Access Compliance Report

Public Rights-of-Way

(Curb Ramps)

Intersection ID: 50583	Main Street: GRAND_FIR_RD	Cross Street: LONGSTRAW_RD	Location: NW
ADA ID: C2D590087EC6	Ramp Type: Perp	Initial Pass/Fail: Fail	Overall Compliance: No
Severity Score: 8.75			
Codes/Mitigation Info/Possible Solution		Field Measurements/Component Compliance

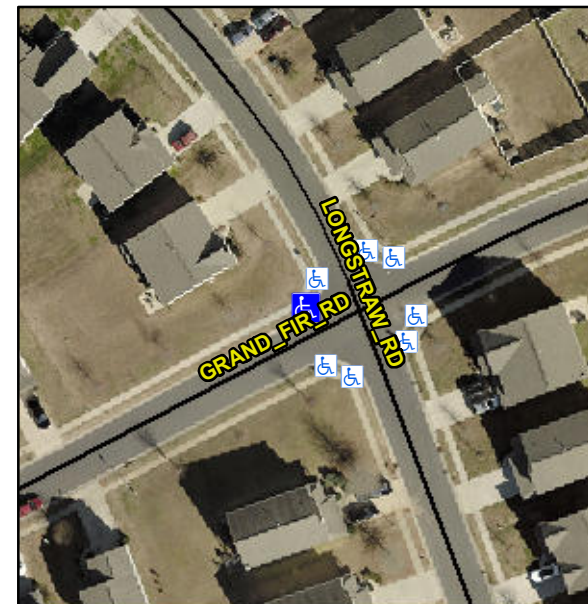
Not Found, R304.5.1

Compliance	Description	Data	Compliance	Description	Data
N/A	Ramp Length (in)	51.0	Yes	Ramp Slope (%)	6.9
No	Ramp Width (in)	47.5	Yes	Ramp XSlope (%)	0.4
N/A	Flare Type LT	N/A	N/A	Flare Type RT	N/A
N/A	Flare Slope LT (%)	N/A	N/A	Flare Slope RT (%)	N/A
N/A	Flare Traversable LT?	N/A	N/A	Flare Traversable RT?	N/A
N/A	Landing Length (in)	N/A	N/A	DWS Provided?	N/A
N/A	Landing Width (in)	N/A	N/A	DWS Contrast?	N/A
N/A	Landing Slope (%)	N/A	N/A	DWS Length (in)	N/A
N/A	Landing X Slope (%)	N/A	N/A	DWS Full Width?	N/A
N/A	Landing Curb? (Y/N)	N/A	N/A	DWS Offset (in)	N/A
N/A	Shared Landing?	N/A			
N/A	Gutter Ponding?	N/A	N/A	Gutter Slope (%)	N/A
N/A	Gutter Lip Ht (in)	N/A	N/A	Gutter X Slope (%)	N/A
N/A	Painted X Walk1?	No	N/A	Painted X Walk2?	N/A
	X Walk 1 Direction	To S		X Walk 2 Direction	N/A
N/A	X Walk 1 Width (in)	N/A	N/A	X Walk 2 Width (in)	N/A
	X Walk 1 Slope (%)	4.3		X Walk 2 Slope (%)	N/A
	X Walk 1 X Slope (%)	0.0		X Walk 2 X Slope (%)	N/A

N/A	Ramp inside XWalk1?	N/A	N/A	Ramp inside XWalk2?	N/A
	Road Slope (%)	N/A	N/A	Clear Space?	N/A
	Road X Slope (%)	N/A	N/A	Clear Space to XWalk (in)	N/A
N/A	Any Obstructions?	N/A	N/A	Storm Grate/Utility Hazard?	N/A
	Obstruction Type			Storm Grate/Utility Type	
		N/A			N/A
			Yes	Surface Condition? (G/P)	Good

Remove & Replace Entire Ramp.
